ICC A117.1 STANDARD
SECOND PUBLIC REVIEW DRAFT
BACKGROUND REPORT

November 7, 2014

ICC/ANSI A117.1 STANDARD
DEVELOPMENT - 2015 EDITION

**ICC A117.1 Standard – Accessible and Usable Buildings and Facilities
Second Public Review Draft – Background Report
November 7, 2014**

Figure 304.3.1

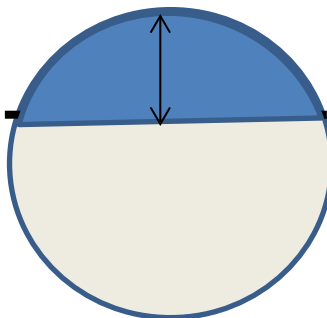
3-8-12 PC1

Figure 308.4.1(a)

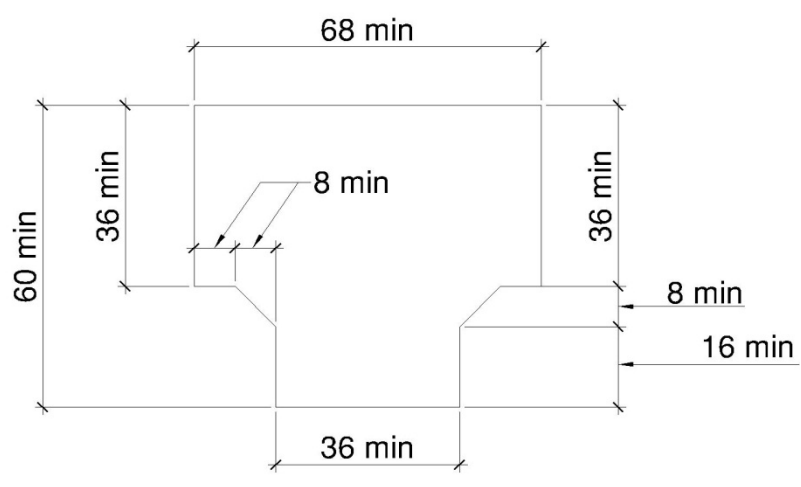
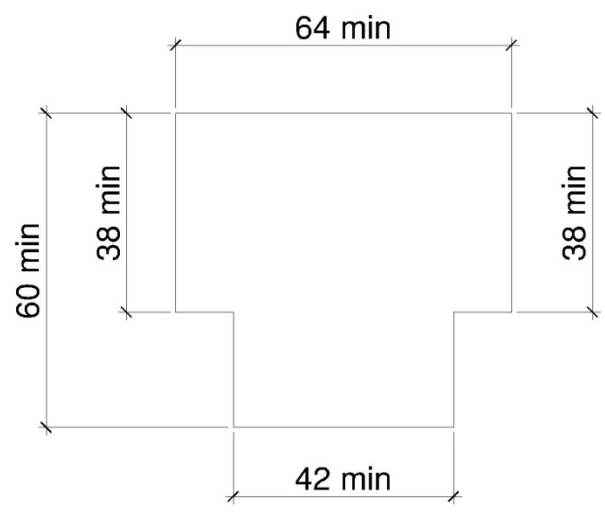
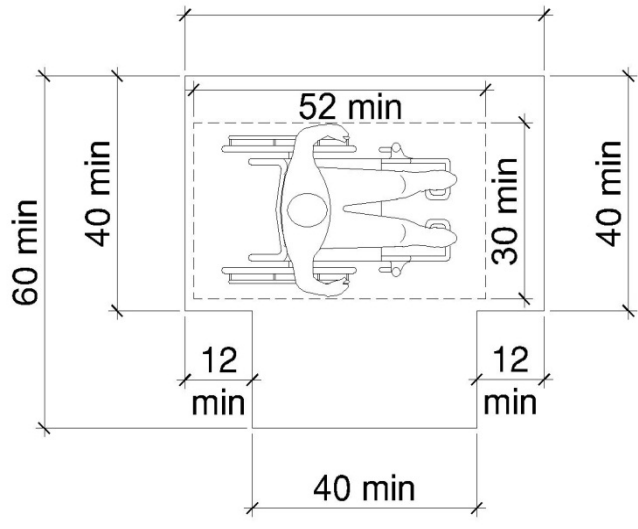
The revisions to the three options in 304.3.2 for the T-turn is to do the following

- Uses a consistent language for the three options
- Corrects the dimensional error in the third option.

Approve Public Comment 3-9-12 PC3 as shown below; the changes include deleting the table and maintaining the figures. (This is a substitute for the 3-9-12 PC3 as shown above)

5-11-12 Figure One

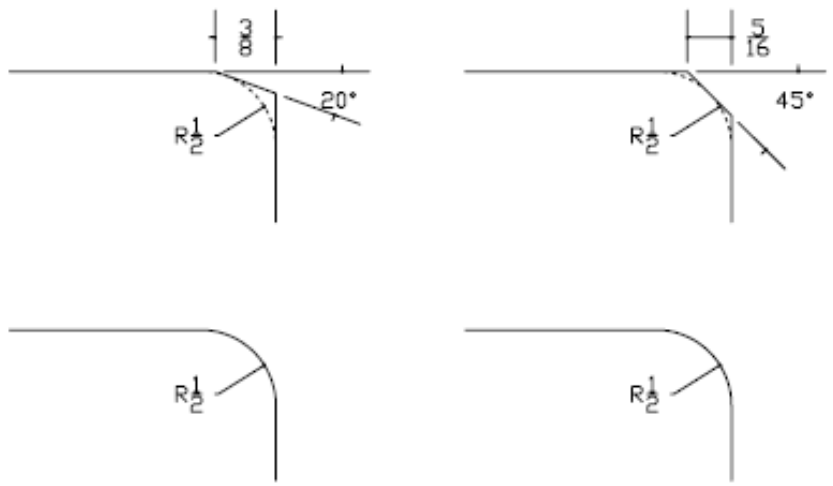
Allowed by Proposed Change 5-11-12
As angle of bevel increases the encroachment on the tread decreases and increases the flat surface of the tread due to the limit imposed by the 1/2 Inch radius.

Committee action on 5-11-12 Unresolved Issue

FIGURE 2 for Issue 5-11-12

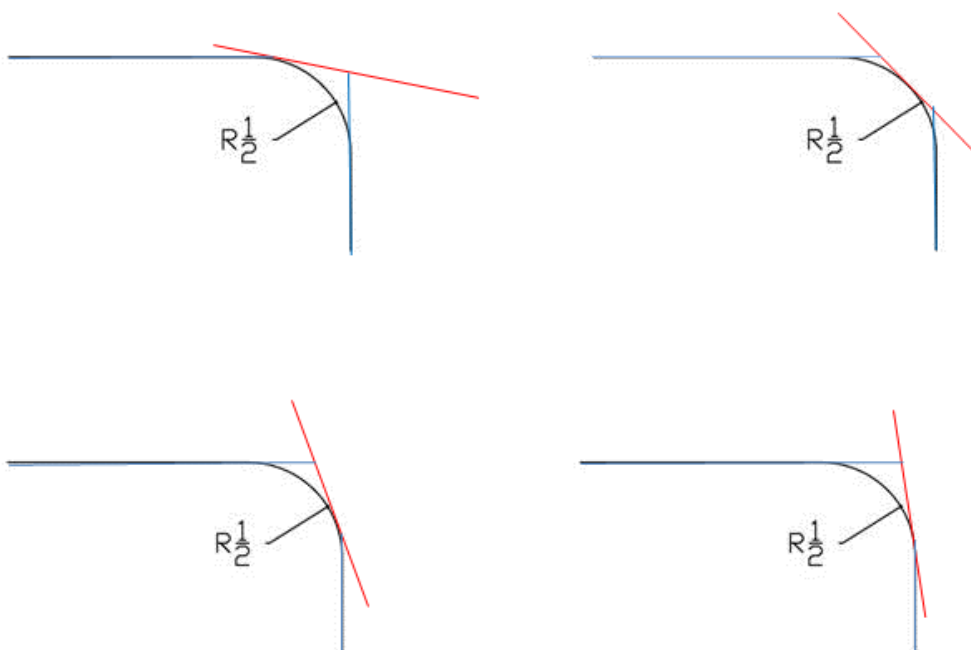
The following **figure 2** shows a section through the tread at the nosing and upper surface of the tread. The “limiting plane” is described as a red line. In each example the “limiting plane” is shown tangent to different points on the $\frac{1}{2}$ inch (13mm) radius of curvature.

FIGURE 504.1

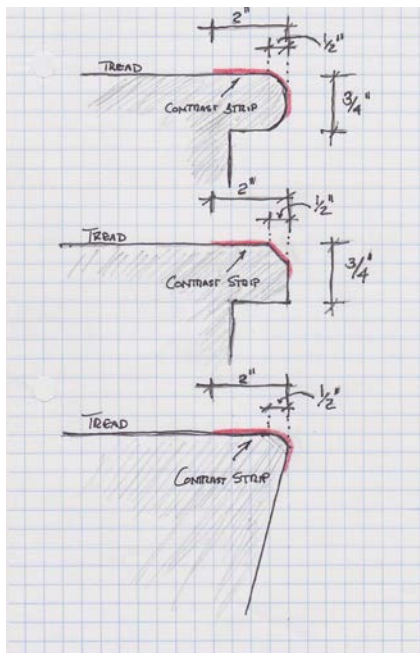
Reason: The concept in Proposal 5-13-13 has great merit, but the committee was unable to agree on adequate language to describe the contrasting edge stripe so that it is clear as to what is required. The proposed language and figure do that.

EXISTING DESIGN

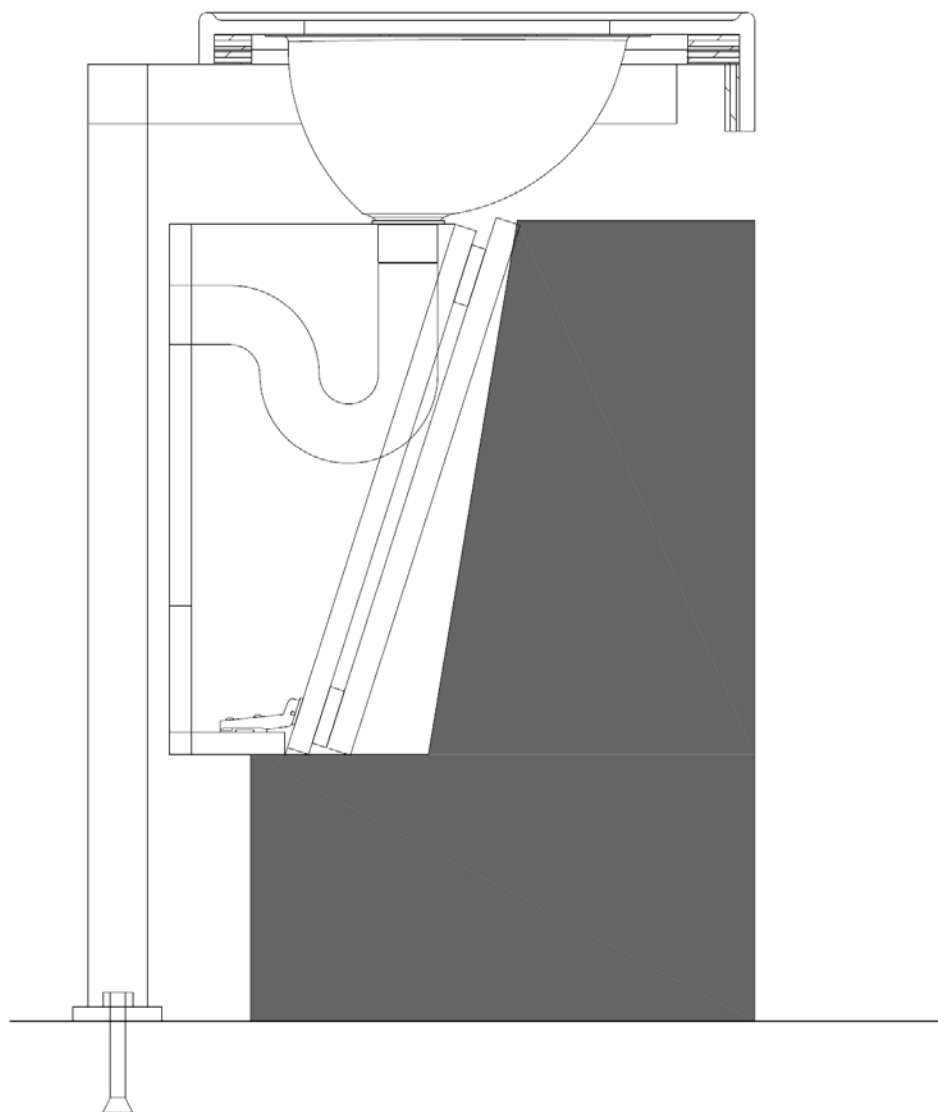
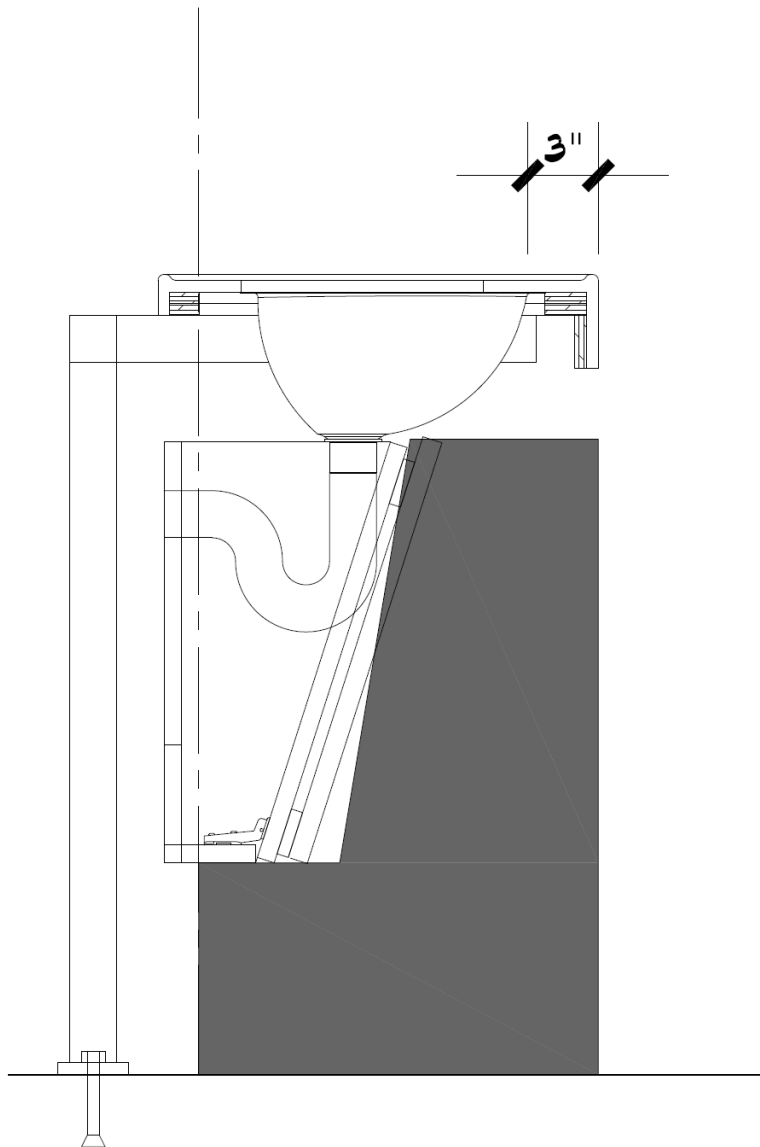
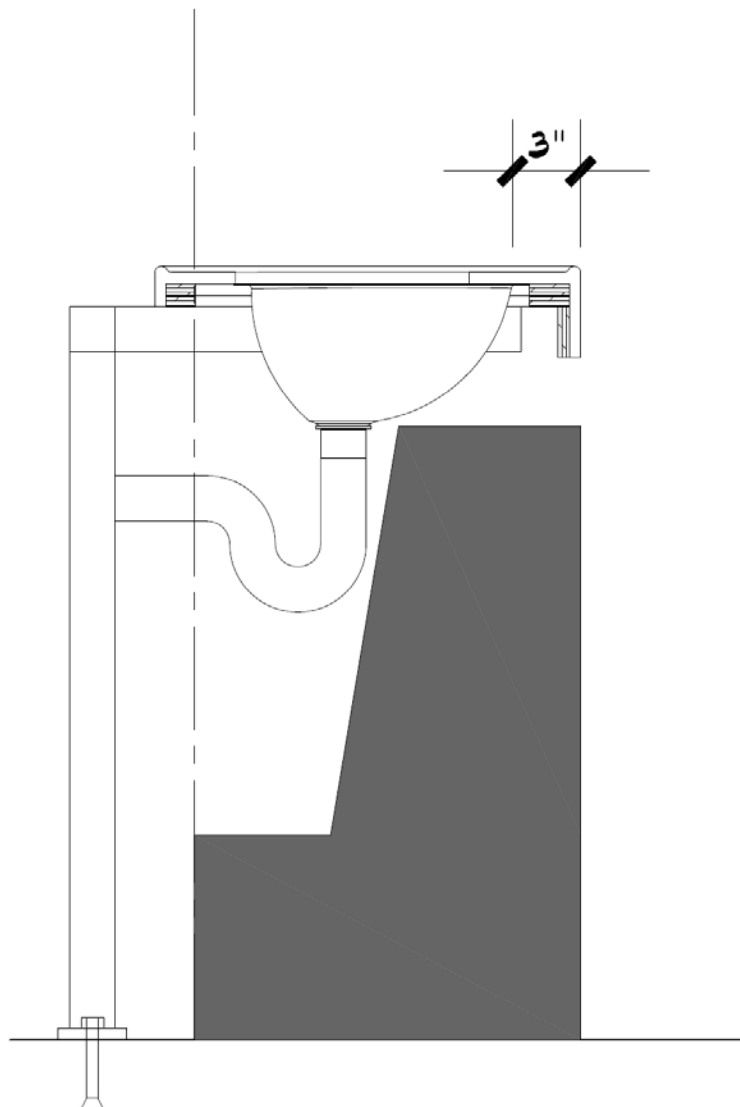
606.5 Basin Location. The interior edge of the rim of the lavatory basin shall be located 3 inches (75 mm) maximum from the front edge of the fixture or countertop.

Existing ANSI 608 Standard Roll-in Shower

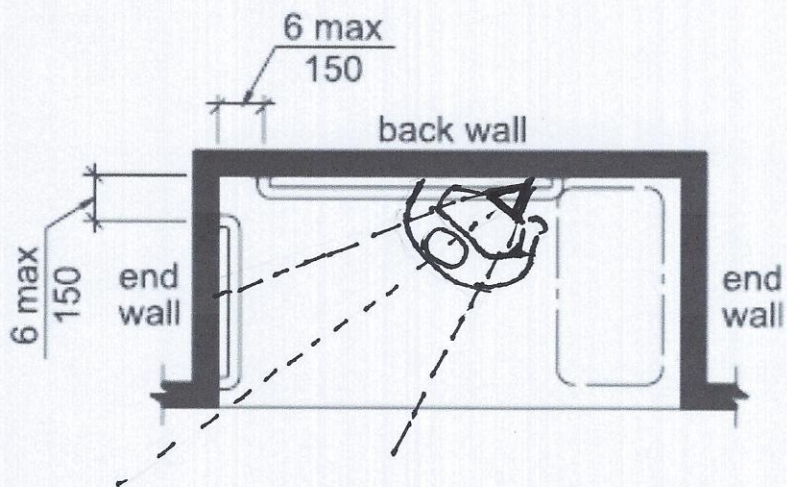
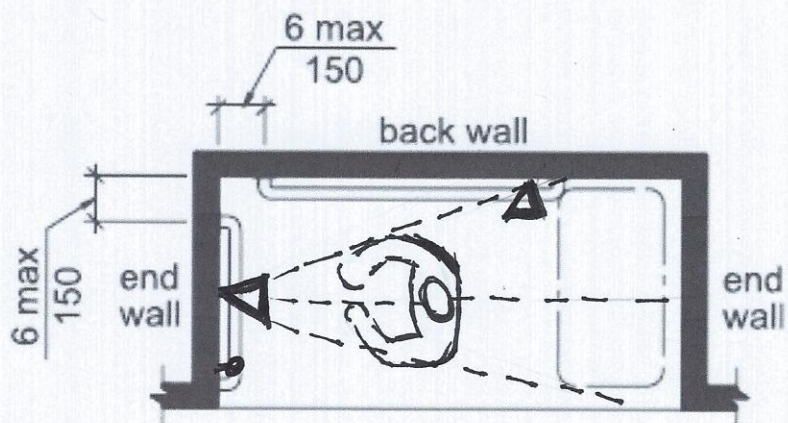
Reason: Many people with walking disabilities prefer to walk into the shower and stand while they shower. People with walking disabilities frequently have knee or hip problems that severely restrict their ability to easily sit and rise from a wet shower seat. The roll-in shower controls and spray located on the back wall are not easily usable by a person who prefers to stand and use the grab bars while showering because the water sprays out into the room and their elbows hit the back wall. Provide option for additional Ambulatory Roll-in Shower Controls and Hand Shower. See sketches at end.

- Half the spray goes out into the room.
- Person must stand as close as possible to spray and their elbows hit the back wall
